SUPPLEMENTARY EXPERT STATEMENT

IN THE MATTER OF: RESOURCE CONSENT SP/0179/20 3MS of Cambridge Limited

Partnership – 1863, 1865, 1871 and 1881 Cambridge Road

STATEMENT OF: Richard Bax, Consultant Engineer

Figure 9: Proposed schematic stormwater layout for the C1 and C2/C3 Growth Cells (also showing future growth cells C7 and C1 Extension)

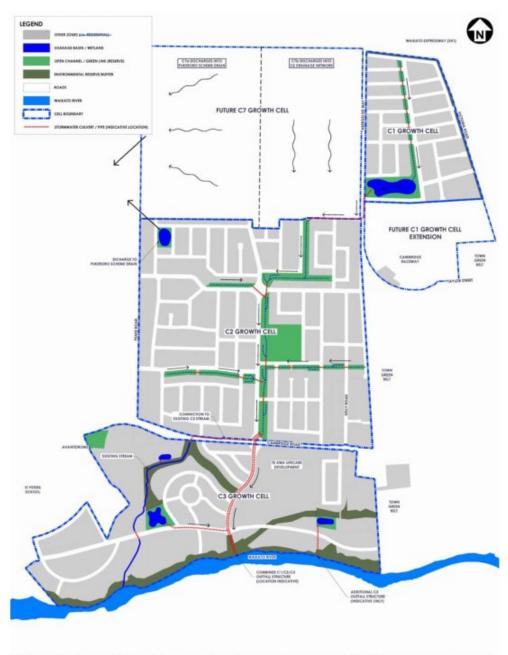
The application proposes to locate critical infrastructure (a north/south collector road and stormwater swale) off the application site, and approximately 100 metres to the

west. This is a significant departure from the planned location of this infrastructure in the Operative Waipa District Plan Structure Plan, which shows it entirely within the applicant's property for this length. This infrastructure is critical to service the upstream growth cells (C1 and C7), and the growth cell it is located within (C2). This infrastructure then feeds into the downstream growth cell (C3). All up, at full development the collector road (including a major intersection with Cambridge Road) will service over 2000 lots (estimated), and the stormwater swale will service around 2500 lots (estimated).

The suggestion by the applicant that this critical Infrastructure can be delayed has implications for servicing other growth cells, including the land owned by St Peter's School in C3. Developments in C1 and eventually C7 as well as others in C2 all require this critical infrastructure. St Peter's school and its Joint Venture partner 3Ms, have indicated that they wish to start developing within the next year. To enable this, the intersection on Cambridge Road is required. However, this cannot be constructed until Council has certainty that the north/south collector road route can be secured.
